STAFF RECOMMENDATION
229 Chapel Avenue
April 17, 2019

Application: New Construction—Outbuilding
District: Eastwood Neighborhood Conservation Zoning Overlay
Council District: 06
Map and Parcel Number: 08302006900
Applicant: Matt Hoiles
Project Lead: Paul Hoffman; paul.hoffman@nashville.gov

<p>Description of Project: Application is to install a shipping container at the rear of the lot, to be used as an outbuilding</p> <p>Recommendation Summary: Staff recommends approval of the project with the conditions:</p> <ol style="list-style-type: none">1. That the outbuilding be clad in an appropriate material, to be approved by MHZC staff;2. That staff approve all window and door selections prior to purchase and installation. <p>With these conditions, staff finds that the project meets Section II.B of the Eastwood Neighborhood Conservation Zoning Overlay design guidelines.</p>	<p>Attachments A: Photos B: Site Plan C: Elevations</p>
--	---

Rear yard showing location at back corner

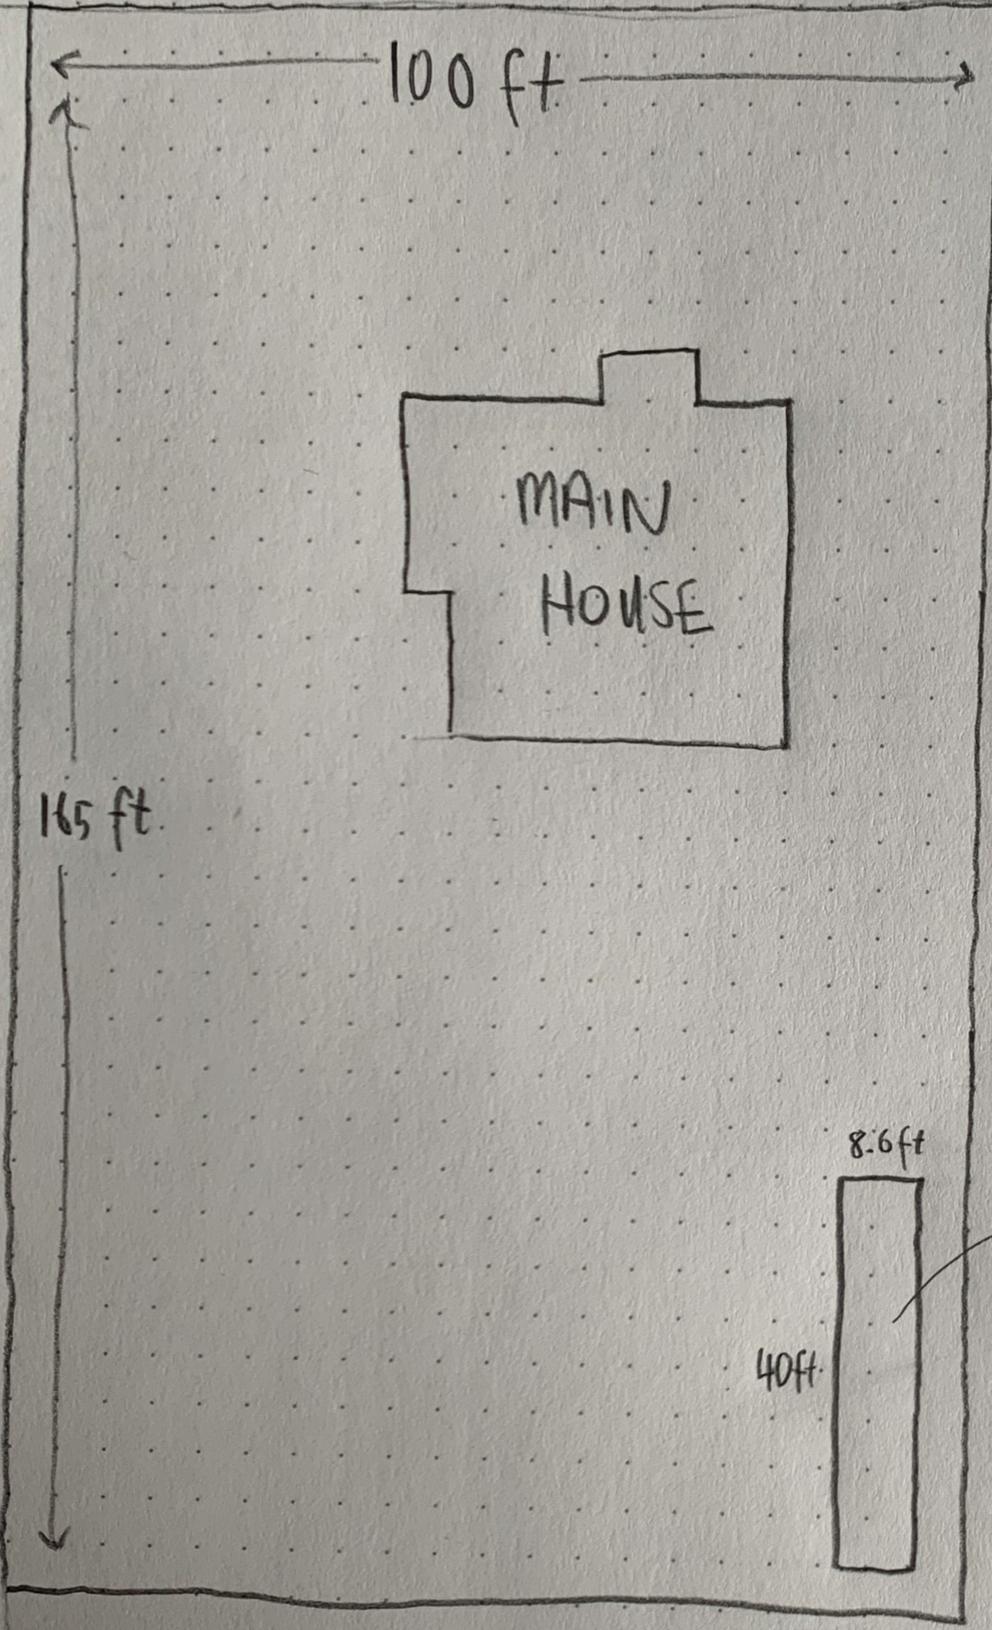
The majority of materials were not indicated. Metal cladding has not been approved as a primary cladding. Staff finds that the container’s metal exterior contrasts greatly with the materials of surrounding historic buildings. Staff recommends that the building be clad in a material that meets the design guidelines, such as wood, fiber-cement lap siding, board-and-batten or brick. With staff’s final approval of the cladding and windows and doors, staff finds that the proposed materials would meet the design guidelines.

MINIMUM	PROPOSED
Building located towards rear of lot	-	Yes
Space between principal building and garage	20'	Approx. 40'
Rear setback	5'	4'
Left side setback	5'	88'
Right side setback	5'	3'
How is the building accessed?	-	n/a
Two different doors rather than one large door (if street facing)?	-	n/a

In conclusion, staff finds that the outbuilding's location, height, scale, roof form, setbacks, meet Sections II.B.h. of the design guidelines and the DADU Ordinance, 17.16.030. G. Staff recommends additional information be provided regarding materials.

1. That the building be clad in an appropriate material, to be approved by MHZC staff; and
2. That staff approve all window and door selections prior to purchase and installation.
